Access Compliance Report

Public Rights-of-Way

(Curb Ramps)

Intersection ID: 30079	Main Street: HARRIS_HOUSTON_RD	Cross Street: HOUSTON_HEIGHTS_RD	Location: NE
ADA ID: 2846FFED82E2	Ramp Type: Perp	Initial Pass/Fail: Fail	Overall Compliance: No
Severity Score: 26.25			
Codes/Mitigation Info/Possible Solution		Field Measurements/Component Compliance

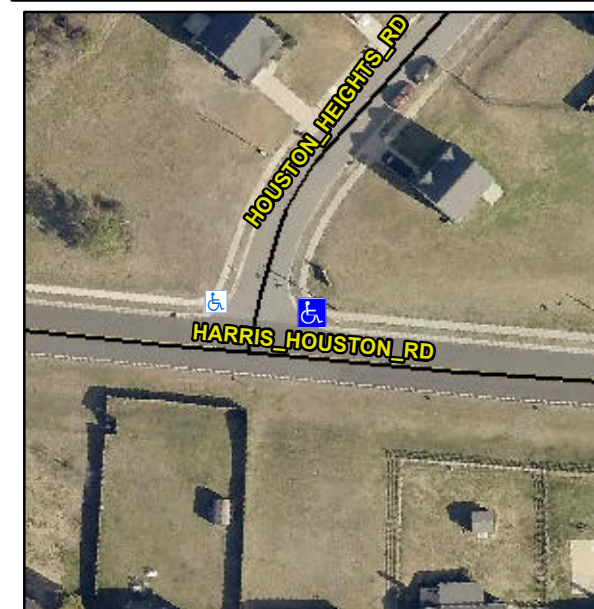
Compliance	Description	Data	Compliance	Description	Data
N/A	Ramp Length (in)	47.0	No	Ramp Slope (%)	12.0
Yes	Ramp Width (in)	67.0	No	Ramp XSlope (%)	4.1
N/A	Flare Type LT	N/A	N/A	Flare Type RT	N/A
N/A	Flare Slope LT (%)	N/A	N/A	Flare Slope RT (%)	N/A
N/A	Flare Traversable LT?	N/A	N/A	Flare Traversable RT?	N/A
N/A	Landing Length (in)	N/A	N/A	DWS Provided?	N/A
N/A	Landing Width (in)	N/A	N/A	DWS Contrast?	N/A
N/A	Landing Slope (%)	N/A	N/A	DWS Length (in)	N/A
N/A	Landing X Slope (%)	N/A	N/A	DWS Full Width?	N/A
N/A	Landing Curb? (Y/N)	N/A	N/A	DWS Offset (in)	N/A
N/A	Shared Landing?	N/A			
N/A	Gutter Ponding?	N/A	N/A	Gutter Slope (%)	N/A
N/A	Gutter Lip Ht (in)	N/A	N/A	Gutter X Slope (%)	N/A
N/A	Painted X Walk1?	No	N/A	Painted X Walk2?	N/A
	X Walk 1 Direction	To W		X Walk 2 Direction	N/A
N/A	X Walk 1 Width (in)	N/A	N/A	X Walk 2 Width (in)	N/A
	X Walk 1 Slope (%)	4.7		X Walk 2 Slope (%)	N/A
	X Walk 1 X Slope (%)	1.1		X Walk 2 X Slope (%)	N/A

Remove & Replace Entire Ramp.
